UNITED STATES ENVIRONMENTAL PROTECTION AGENCY
REGION 6
1445 ROSS AVENUE, SUITE 1200
DALLAS, TEXAS 75202-2733

SUBJECT: Impromptu visual cap inspection at the San Jacinto River Waste Pits superfund site

FROM: Valmichael Leos, Remedial Project Manager
LA/NM/OK Remedial Section (6SF-RL)

Figure 1- Areas covered with additional rock and flatten slopes from November 2013 Armor Cap Enhancement plan

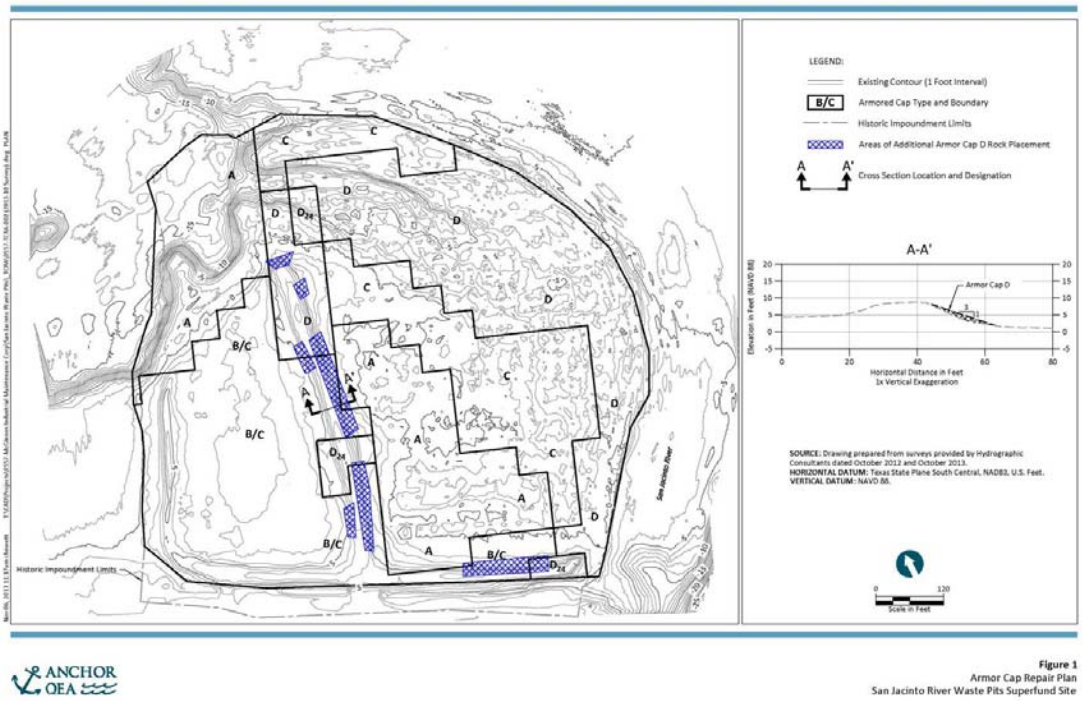
In addition to inspecting the overall integrity of the armor cap, seven additional areas (see Figure 1) were inspected where additional rock was placed and the slopes flattened to provide more stability and strength per the enhancement work plan dated November 2013. The section of the armor cap located above water level (western cell) was observed to be intact with no areas of cap erosion evident (see Photo 1-2). It was noted that several small areas of minor cap erosion along the central berm were evident by patches of the geotextile filter fabric exposed (See Photos 3-5).
